E8362BH85-06**S E R V I C E N O T E**Supersedes:
NONE**E8362BH85 PNA Series RF Network Analyzers****Serial Numbers: MY00000000 - MY47020122****Add-on mechanical components to enhance instrument reliability****To Be Performed By: Agilent-Qualified Personnel or Customer with specific product repair knowledge – requires instrument disassembly and component replacement.****Parts Required:**

Further design review has suggested the addition of a clamping mechanism to ensure that the 8121-0118 ribbon cable can not vibrate loose from the Test Set Motherboard connector during extreme handling.

McMaster Carr item 6959A18 (T-10 torx size L-key)

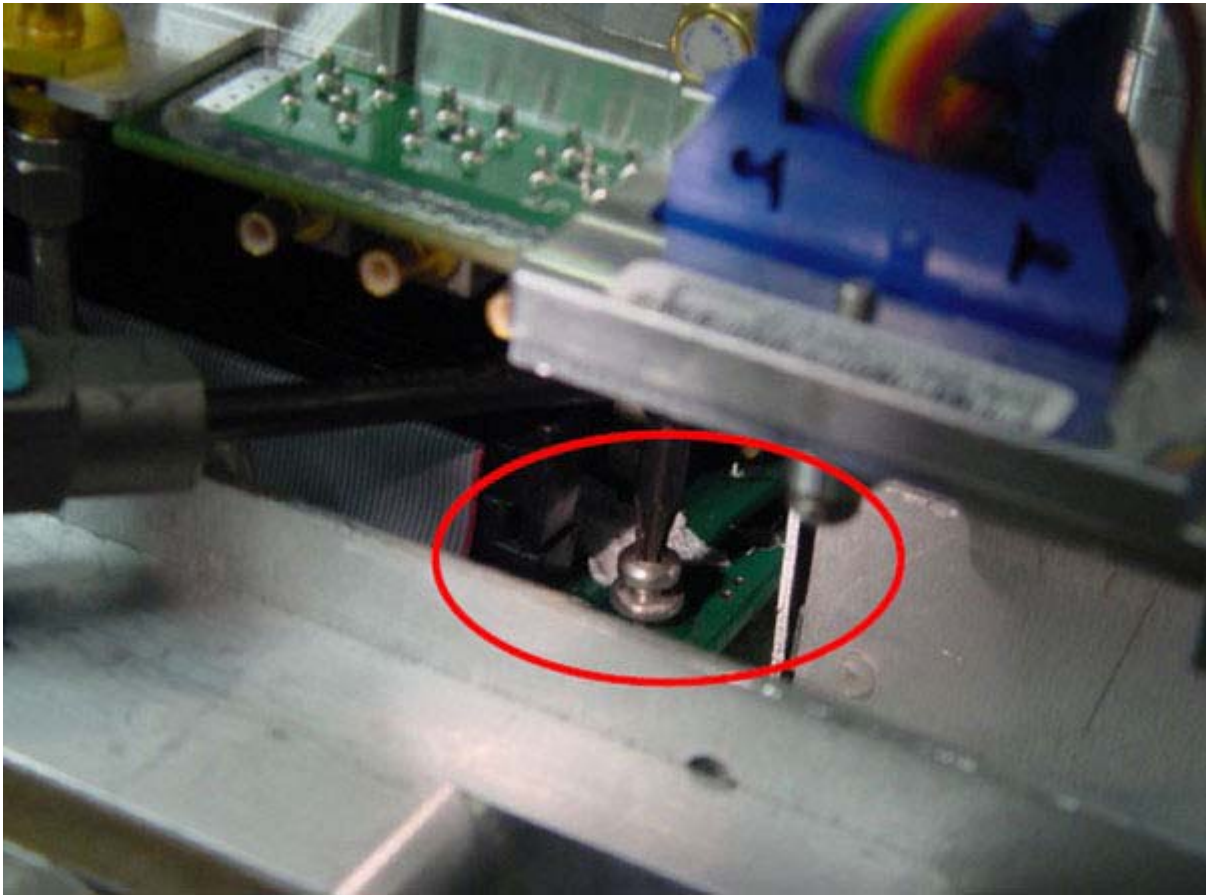
- a. Gather a standard 10 lb-in breakaway wrench (used for semi-rigid cables).

- b. Remove the open end head by loosening set screw. It will be replaced with L-Key shown below.

- c. Secure and orient the L-Key to the breakaway handle

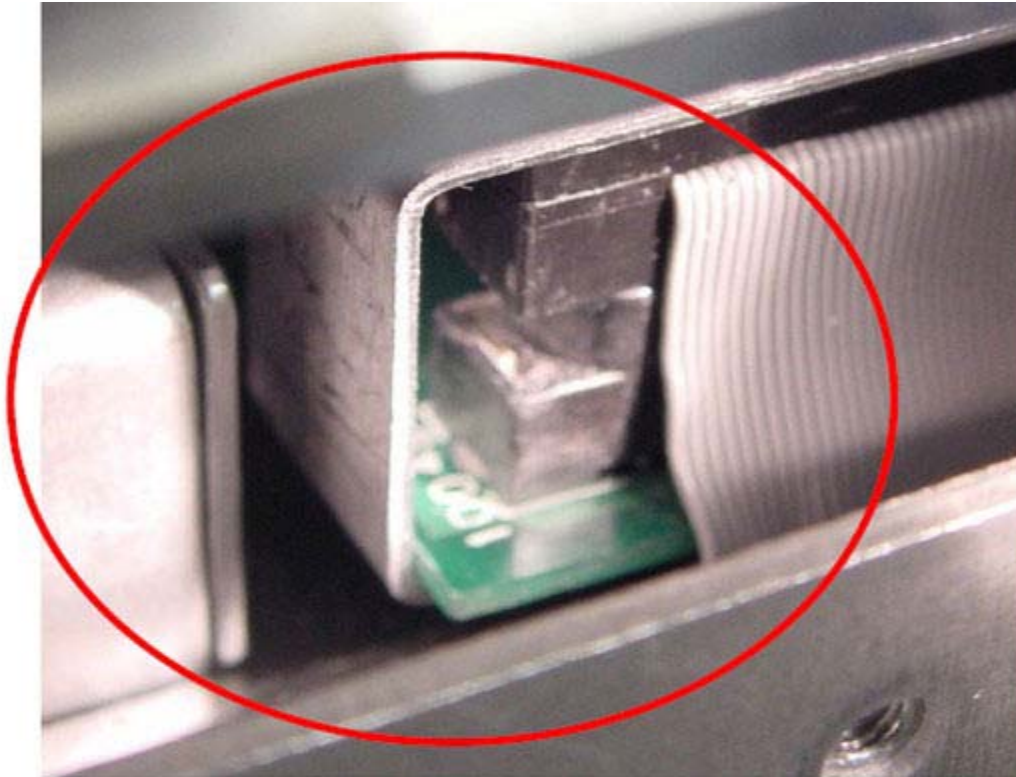
- a. Remove and discard existing screw near ribbon cable connector on System Motherboard. See below.

- b. Insert Ribbon Cable Clamp under Source Assembly as shown.

- c. Position the clamp over the Ribbon Connector. Use needle nose pliers if necessary to slide the clamp into place. Ensure that the edge of the clamp is parallel to the connector and not skewed.

NOTE: Ensure that the Clamp Lip is secured **BELOW** the edge of the System Motherboard

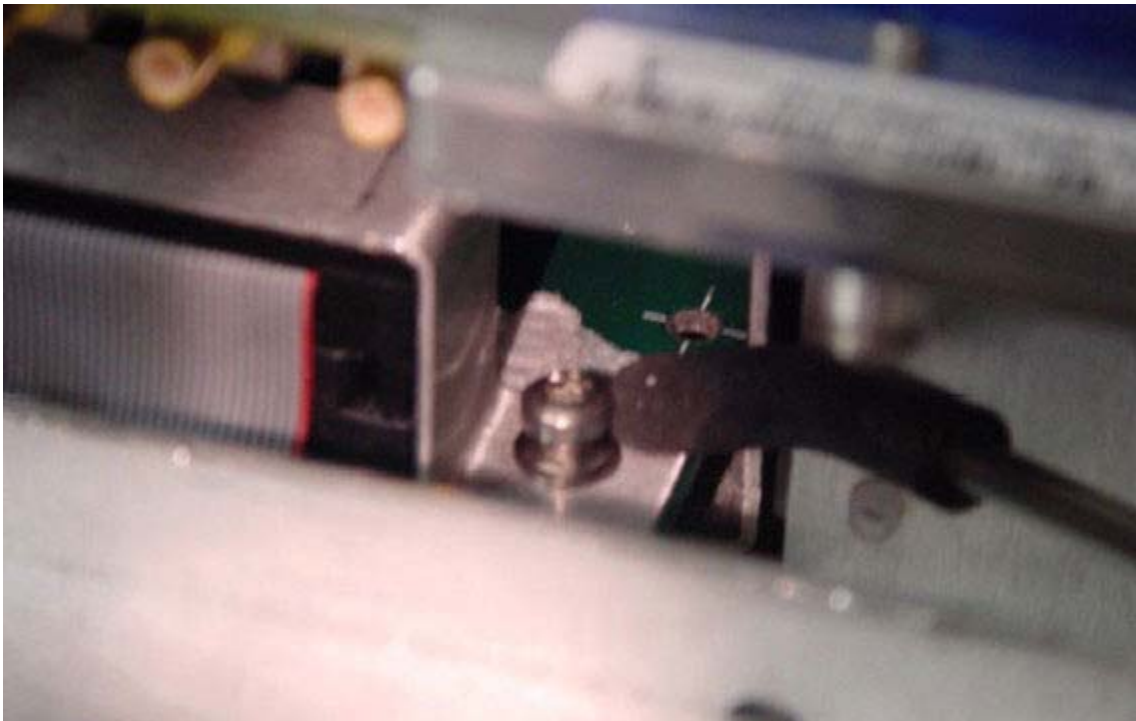
- d. Using tweezers, install a new 0515-0374 screw through the hole in the bracket.

- e. Use a nut runner tool (T-316130) or alternatively a clean erasure end of a pencil to help run the screw.

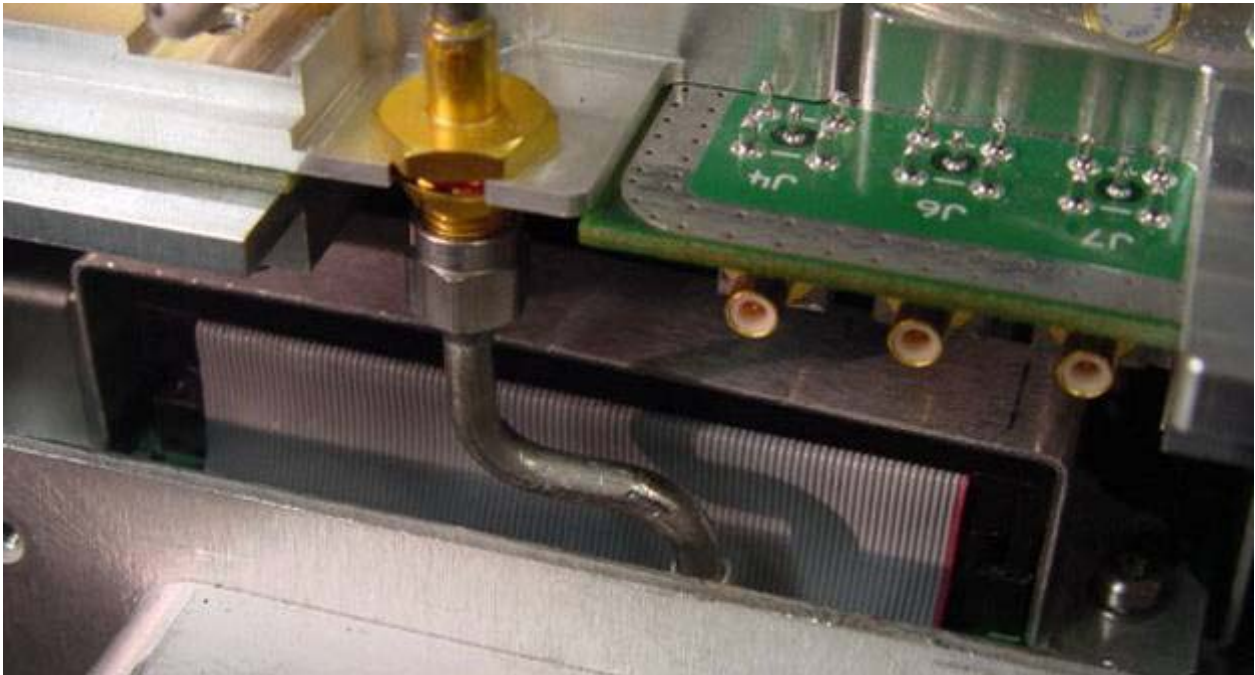
- f. Secure screw using the modified 10 lb-in breakaway wrench.

- g. This image shows the final position of the secured clamp.

Figure 2a

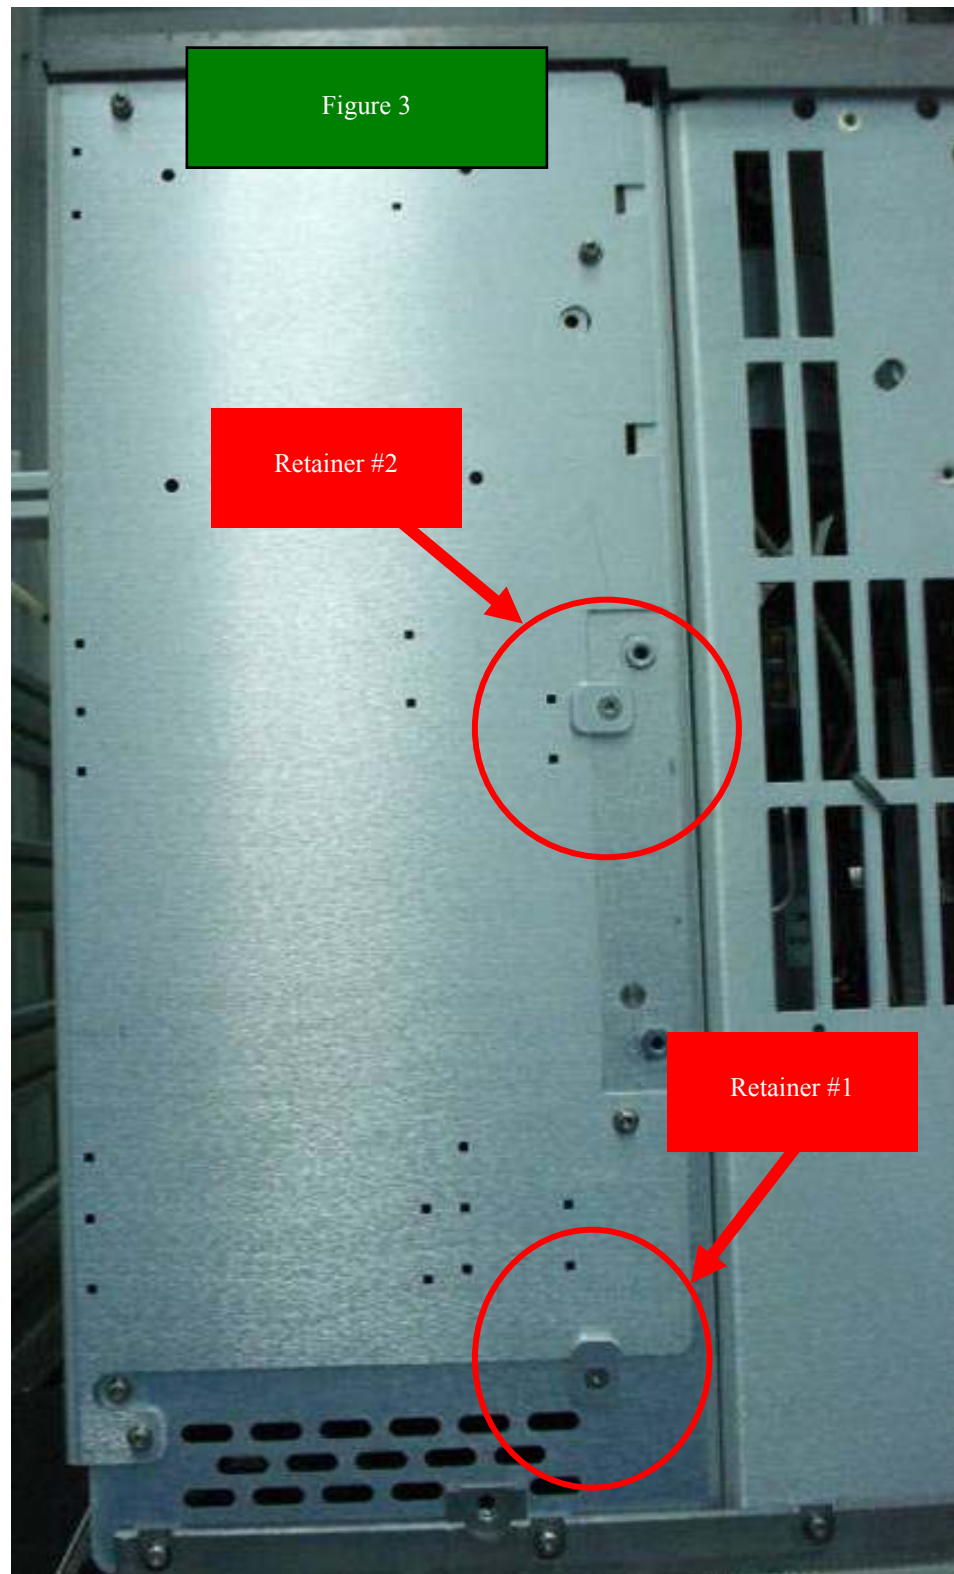
The Clip Retainer (E8361-20067) to be secured with Flat Head screw (0515-1644) in 2 places at 9 lb-in. This Retainer Clip may naturally rotate a bit when being secured, which is acceptable. Note that the existing screw needs to be removed and discarded prior installing Retainer Clip #1 (shown below in Figure 2a, 2b, and 3).
